Optimization Review
Groveland Wells Numbers 1 and 2 Superfund Site
Town of Groveland, Essex County, Massachusetts

OPTIMIZATION REVIEW

Report of the Optimization Review
Site Visit Conducted at the Groveland Wells Numbers 1 and 2 Superfund Site on
February 29, 2012

FINAL REPORT
January 7, 2013

Figure 6-1. Flow Chart Illustrating Suggested Decision Framework

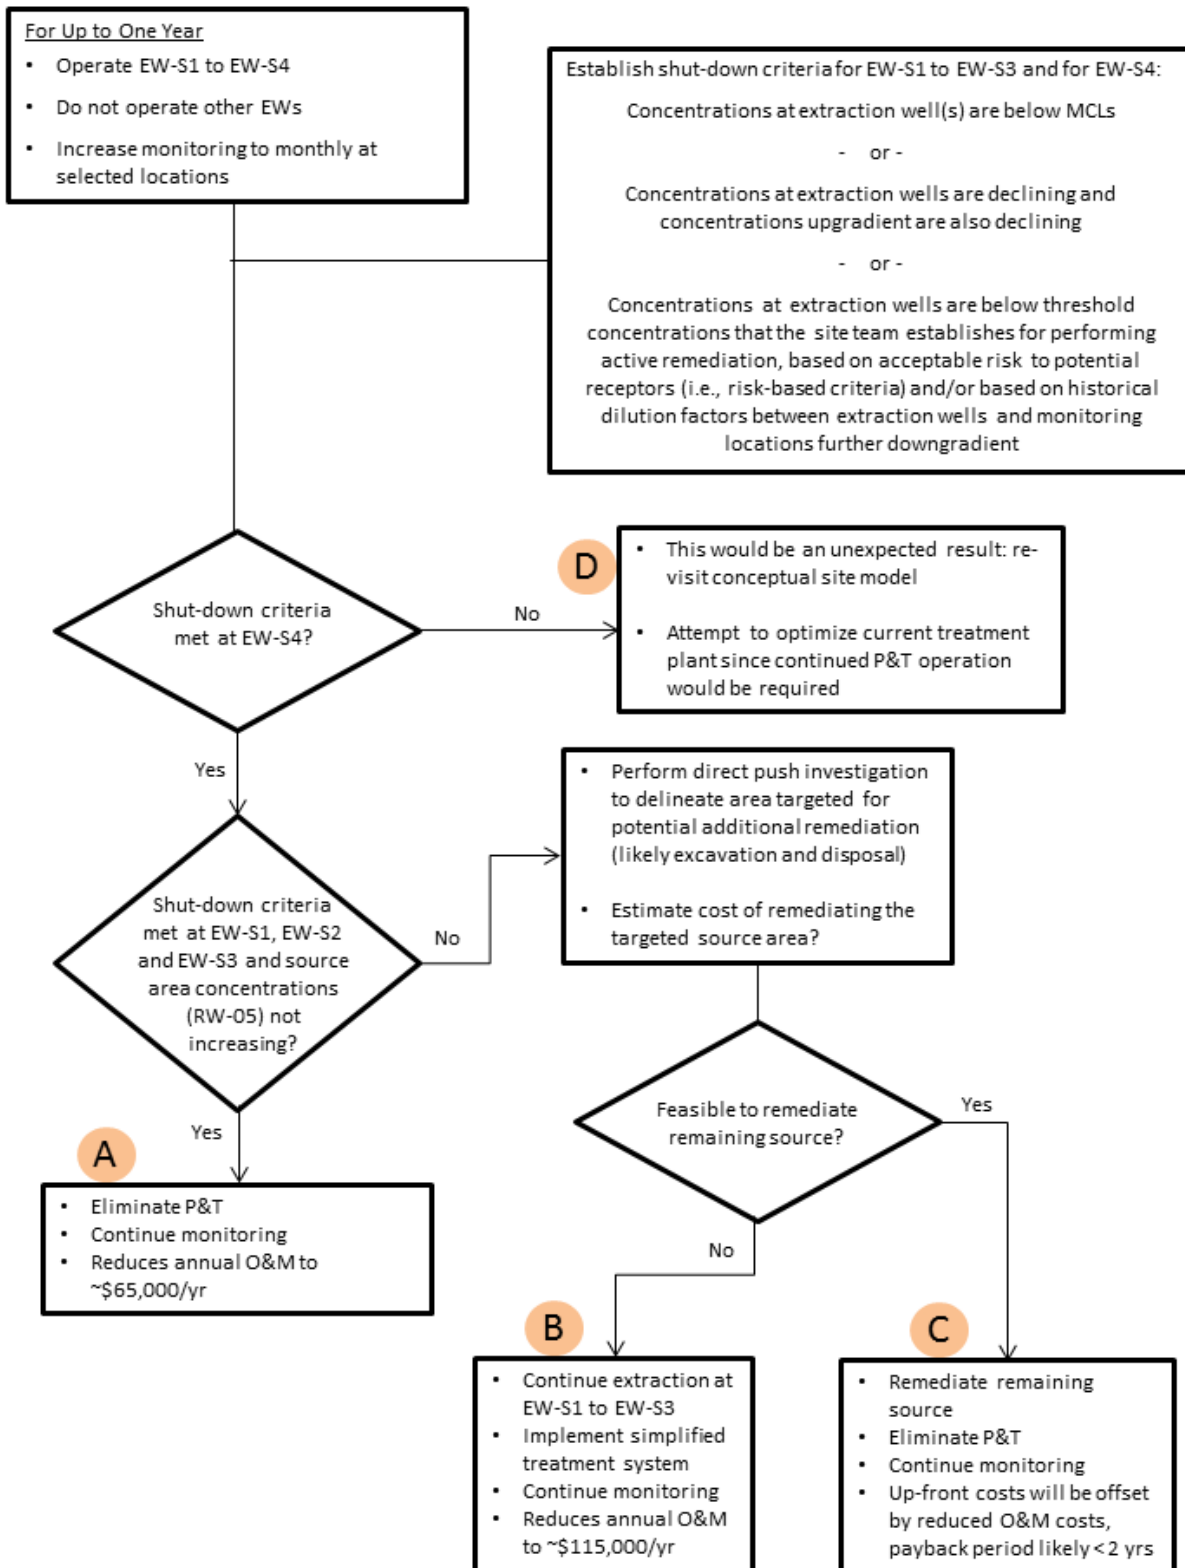
The recommendations described below are inter-related, and an overall decision framework in the form of a flowchart is illustrated on Figure 6-1 to illustrate those interrelationships. The flowchart begins with a limited period of P&T operation that includes operation of extraction wells EW-S1 through EW-S3 plus EW-4 (see Section 6.1.1), and potential outcomes are identified as “A” through “D” on Figure 6-1. An alternative approach that does not include operation of extraction wells EW-S1 through EW-S3, and a discussion of the advantages and disadvantages of that alternative approach, is presented in Section 6.1.2.

With respect to the recommendation described in Section 6.1.1, the site team could consider an alternative approach in which extraction wells EW-S1 through EW-S3 are not returned to operating status during the initial monitoring period. EW-S4 would continue to operate, and the GTWF would still be needed. This approach might entirely eliminate the re-start of those three extraction wells if the shutdown criteria for EW-S1 through EW-S3 and EW-S4 can all be met, resulting in Outcome “A” on Figure 6-1. However, there is additional risk in pursuing this alternative because there is a possibility that the shutdown criterion for EW-S4 (see Section 6.4.1) might not be met in the absence of extraction at EW-S1 through EW-S3. If that occurred, it would eliminate the potential to achieve outcomes “A,” “B” or “C” on Figure 6-1 in the short-term (i.e., it would delay potential elimination or substantial streamlining of the current GWTF), and would complicate subsequent decisions. The decision framework illustrated on Figure 6-1 allows for a more straightforward decision-making process.

- *Outcome “A” on Figure 6-1.* A likely potential outcome is that P&T operations at this site will be terminated within 1 year (and perhaps much less than 1 year). If that occurs, the current cost of \$345,600 per year would likely be reduced to approximately \$65,000 per year (assuming \$25,000 per year for project management and \$40,000 per year groundwater monitoring). Thus, cost would be reduced by approximately \$280,000 per year for this scenario versus the current P&T system.

- *Outcome “B” on Figure 6-1.* Another potential outcome is that P&T extraction can be limited to source area wells EW-S1 through EW-S3 within 1 year, and the associated flow rate would allow for a simpler treatment approach. The current cost of \$345,600 per year would likely be reduced to approximately \$115,000 per year (assuming \$65,000 per year for the scenario with no P&T described above, plus an additional \$50,000 per year associated with management and operation of a smaller P&T system as detailed in Section 6.4.2). Thus, cost would be reduced by approximately \$230,000 per year for this scenario versus the current P&T system. It is expected that treatment plant modifications for this scenario would require up-front costs of approximately \$50,000, with payback achieved in much less than 1 year.

- *Outcome “C” on Figure 6-1.* Another potential outcome is that additional source area remediation (likely to consist of excavation and disposal) may be required in a targeted area to enable the complete shutdown of P&T operations. Based on the size of the targeted area, the up-front costs might range from less than \$100,000 to \$500,000 or more, as discussed in Section 6.4.2. These up-front costs would be offset by annual savings of approximately \$280,000 per year that would result from complete termination of P&T operations (as discussed in Outcome “A” above). Thus, the payback period might range from less than 1 year to as much as several years for this scenario.

- *Outcome “D” on Figure 6-1.* An unexpected outcome would be that downgradient extraction well EW-S4 needs to continue operating because the remaining source area is sufficiently strong and the capture provided by EW-S1 through EW-S3 is not sufficient. If this outcome occurs after the first year, it would then be appropriate to re-visit the CSM, and to optimize the current GWTF since continued P&T operation would be required.

A potential approach for addressing these shutdown criteria is indicated on Figure 6-1. However, determining the shutdown criteria for the extraction wells is not solely a technical decision, thus the optimization review team cannot provide more specific recommendations or opinions. If there is concern or uncertainty about selecting shutdown criteria, the EPA and MassDEP may decide to devise a contingency plan that allows extraction well operation to resume after shutdown if concentrations at pre-determined monitoring points increase above a pre-determined action level. The optimization review team believes that the primary effort involved in implementing this recommendation involves meetings between the EPA and MassDEP. Limited contractor support for these meetings might cost up to \$10,000.

Given the focus on site closure (i.e., the expectation that the current P&T system will only operate for a short amount of time), no opportunities for footprint reduction regarding the current P&T system (for example, treatment plant upgrades) were contemplated. However, to the extent P&T operations are terminated or significantly scaled back within a year or less (which is likely based on the discussion above), remedy footprints will be reduced accordingly. The actual footprint reductions will depend on which of the potential outcomes on the decision flowchart presented on Figure 6-1 actually occurs (i.e., similar to the potential cost savings).
